SERVICE BULLETIN REVISION NOTICE

ENGINE — STARTER AND TAI DUCT SYSTEM — INTRODUCTION OF NEW MORE DURABLE BEARING LINK ASSEMBLIES

Turbojet Engine Service Bulletin No. V2500-ENG-80-0022 Revision No. 1 dated October 29, 2014.

SERVICE BULLETIN

REPLACEMENT OF STARTER DUCT BEARING LINK ASSEMBLIES FIGURE 1

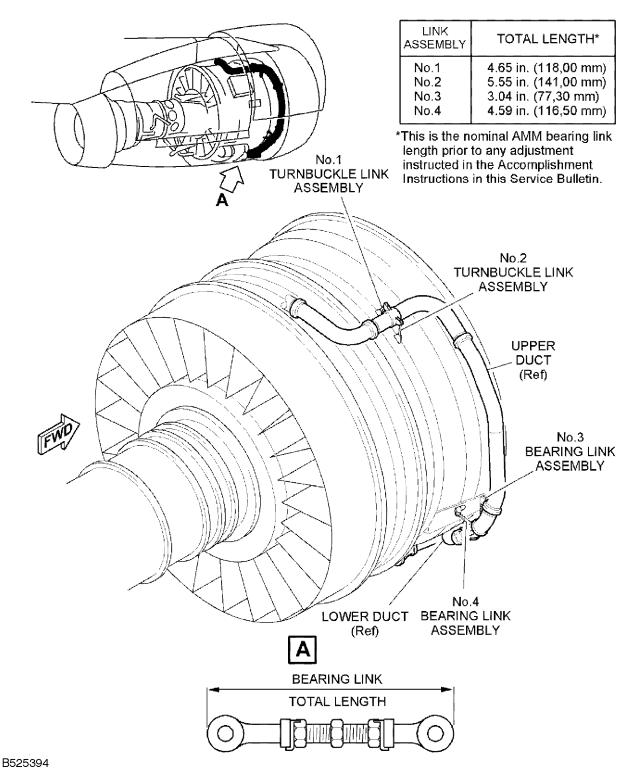
- 1. The four bearing link assemblies on the LH or RH Air Starter system are removed according to the existing Maintenance Manual instructions. The ducting is allowed to settle in a state that is free of any tension.
- 2. The number one and two bearing link assemblies on the LH or RH Air Starter system are then replaced with turnbuckle link assemblies. The turnbuckle link assemblies are installed under torque controlled conditions to introduce positive axial pre-load in accordance with the accomplishment instructions in this Service Bulletin.

- 3. The existing number three and four bearing link assemblies are inspected for wear and if serviceable, are re-installed. The bearing link assemblies are then rigged in accordance with the accomplishment instructions in this Service Bulletin to introduce positive axial load.

PART A — Replacement of the bearing link assemblies on the Air Starter — LH or RH Engine (Refer to Figure 1)

- (1) Adjust the central connecting rod nut at position one to make the overall length of the turnbuckle link an approximate nominal length of 4.65 in (118.00 mm).
- (2) Adjust the central connecting rod nut at position two to make the overall length of the turnbuckle link an approximate nominal length of 5.55 in (141.00 mm).
- (3) Make further adjustments to the turnbuckle link at position one to set the link to a length that just permits you to put in the bolts at the end of the turnbuckle link. Tighten the turnbuckle link bolts in accordance with the Aircraft Maintenance Manual, TASK 80-13-49-400-010.
- (4) Make further adjustments to the turnbuckle link at position two to set the link to a length that just permits you to put in the bolts at the end of the turnbuckle link. Tighten the turnbuckle link bolts in accordance with the Aircraft Maintenance Manual, TASK 80-13-49-400-010.

- (5) Torque the central adjustment nut on the connecting rod at position one to 25 lbf in (2.8 Nm). Apply the torque so that it will reduce the length of the turnbuckle link. Refer to the Aircraft Maintenance Manual, TASK 70-23-11-911-013.

- (6) Torque the central adjustment nut on the connecting rod at position two to 25 lbf in (2.8 Nm). Apply the torque so that it will reduce the length of the turnbuckle link. Refer to the Aircraft Maintenance Manual, TASK 70-23-11-911-013.

- (10) Adjust the length of the bearing link at position three to the nominal length of 3.04 in (77.4 mm) as shown.
 - NOTE: The male/female bearing link at position three may require full adjustment to make the total length of the link as short as possible.

- (11) Adjust the length of the bearing link at position four to the nominal length of 4.59 in (116.5 mm) as shown.
- (12) Make further adjustment to the bearing link at position three to set the link to a length that just permits you to put in the bolts at the end of the bearing link.

- (14) Shorten the length of the bearing link at position three by the application of a half turn (180 degrees) in a clockwise direction.
 - NOTE: Make sure you make a reference mark on the bearing link before you make the following adjustments.

- (15) Shorten the length of the bearing link at position four by the application of a full turn (360 degrees) in a clockwise direction.
- (16) Install the bearing links at positions three and four. Tighten the lock nuts at each end of the bearing links and bend the washer tabs to make sure the lock nuts are tight.

REPLACEMENT OF TAI BEARING LINK ASSEMBLIES FIGURE 2

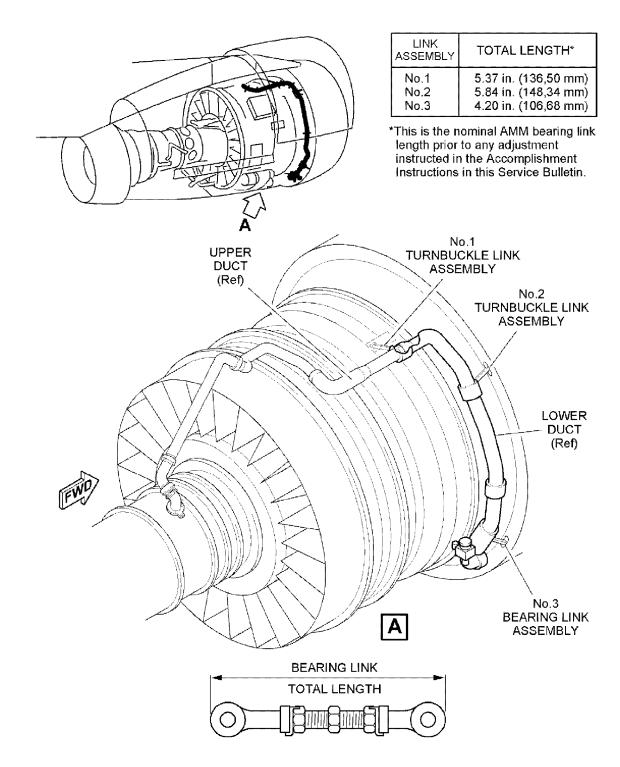
- 4. The three bearing link assemblies on the LH or RH TAI system are removed in accordance with the existing Maintenance Manual instructions. The ducting is allowed to settle in a state that is free of any tension.

- 5. The number one and two bearing link assemblies on the LH or RH TAI system are replaced with turnbuckle link assemblies. The turnbuckle link assemblies are installed in accordance with the accomplishment instructions in this Service Bulletin.

- 6. The existing number three bearing link assembly is inspected for wear and if serviceable, is re-installed. The bearing link assembly is then rigged in accordance with the accomplishment instructions in this Service Bulletin.

PART B — Replacement of the bearing link assemblies on the TAI Ducts — LH or RH Engine (Refer to Figure 2)

- (1) Adjust the central connecting rod nut at position one to make the overall length of the turnbuckle link an approximate nominal length of 5.37 in (136.5 mm).

- (2) Adjust the central connecting rod nut at position two to make the overall length of the turnbuckle link an approximate nominal length of 5.84 in (148.34 mm).

- <u>NOTE</u>: Make sure that there is a minimum clearance of 0.23 in (6.0 mm) between the gimble insulation and the fan case after link adjustment.
- (5) Tighten the turnbuckle link nuts either side of the central adjustment nut at position one and bend the washer tabs to secure in position. Refer to the Aircraft Maintenance Manual. Refer to the Aircraft Maintenance Manual, TASK 70-40-11-911-014.

- (7) Visually inspect the bearing link assemblies at position three. If serviceable, undo the lock nuts to permit the adjustment of the bearing link.
- (8) Adjust the length of the bearing link at position three to the nominal length of 4.20 in (106.68 mm) as shown.

- (9) Shorten the length of the bearing link at position three by the application of a half turn (180 degrees) in a clockwise direction.
- (10) Install the bearing link at position three. Tighten the lock nuts at each end of the bearing link and bend the washer tab to secure in position.
- D. Close the Fan Cowl Doors as instructed in the V2500-A5 Aircraft Maintenance Manual, Task 71-13-00-410-010.
- 2. Record of Accomplishment
 - A. A record of accomplishment is necessary. Write in the applicable records that Service Bulletin V2500-ENG-80-0022 PART A and/or PART B have been done.
